Re: Turkey Point Units 3 and 4
Docket Nos. 50-250 and 50-251
Response to NRC Request for Additional Information (RAI) Regarding Extended Power Upate (EPU) License Amendment Request (LAR) No. 205 and Electrical Engineering Branch Issues

Turkey Point Units 3 and 4

**RESPONSE TO NRC RAI REGARDING EPU LAR NO. 205
AND EEEB ELECTRICAL ENGINEERING BRANCH ISSUES**

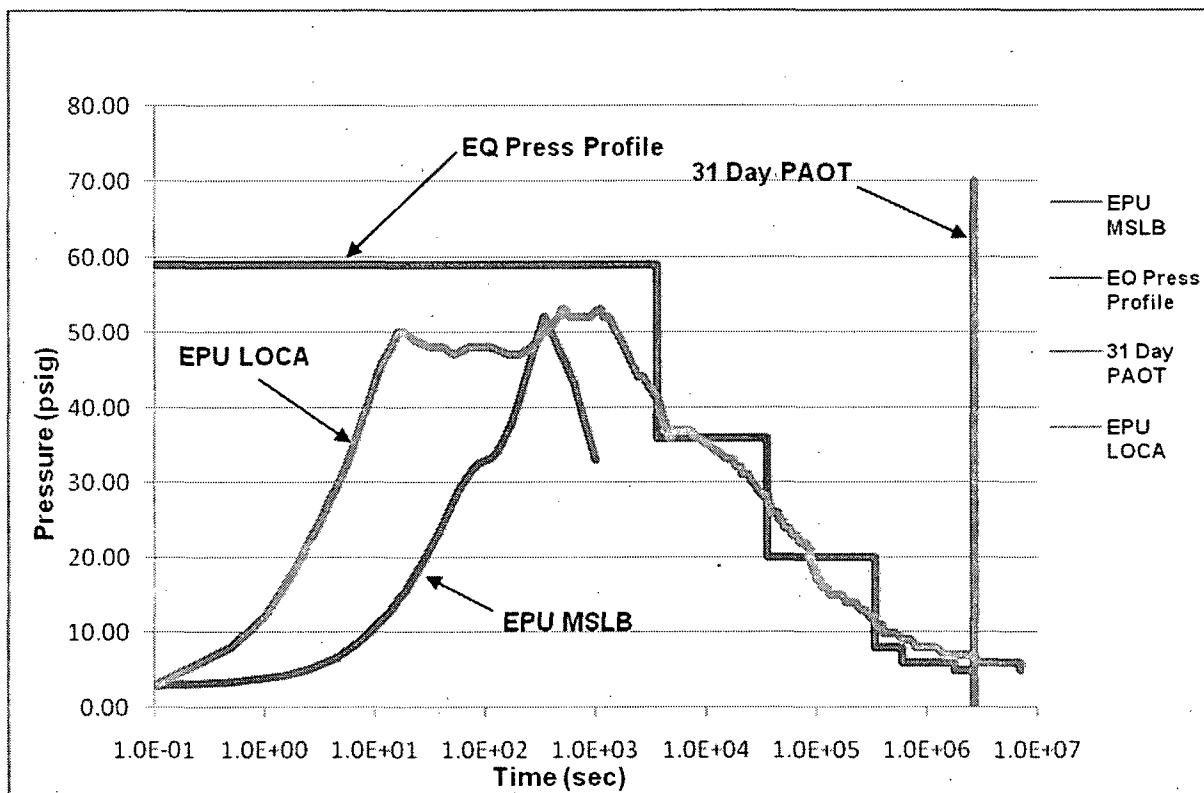
- b. **Explain how the margins identified in the Institute of Electrical and Electronics Engineers Standard 323-1974 (i.e., Temperature, Pressure, etc.) are being maintained under EPU conditions.**

- c. **Figure 2.3.1-1 appears to show that the required temperature margin (15 degrees Fahrenheit) is not being maintained. Clarify the apparent deviation.**

The difference between the EQ Qualification (Qual) Envelope and the EPU LOCA temperature curves is that the EPU LOCA temperature curve does not drop below a 15°F margin until after at least 2.7 hours when the temperature is declining and any potential damage would have already occurred. In addition, the EQ Qual Envelope temperature steps show a higher temperature is maintained for significantly longer than the EPU LOCA temperature curve. This adds margin since electrical equipment aging is a function of temperature and duration. Therefore, the margin added due to maintaining a longer duration at higher temperatures is considered adequate for qualification.

The difference between the EQ and the EPU pressure design curve is that the EPU pressure design curve does not drop below 10% margin until after at least 50 minutes at which time both the design and EQ curves decrease by at least 20 psi. Since the first time step, which is at the highest pressure, provides greater than 10% margin for the entire time step, additional margin over the 10% IEEE 323 guideline is provided. The remaining time steps maintain the EQ profile at constant pressure above the design profile for the majority of the time step and build margin greater than 10% that compensates for the subsequent time steps where the 10% margin is not achieved. As stated above, the damage mechanism associated with pressure is not age-related, but a function of the pressure magnitude which causes greater moisture intrusion. Since the EQ profile maintains the pressure above the design profile for a greater duration and the maximum pressure is above 10% of design, the developed margin is considered adequate for qualification.

See response EEEB-1.1.b above
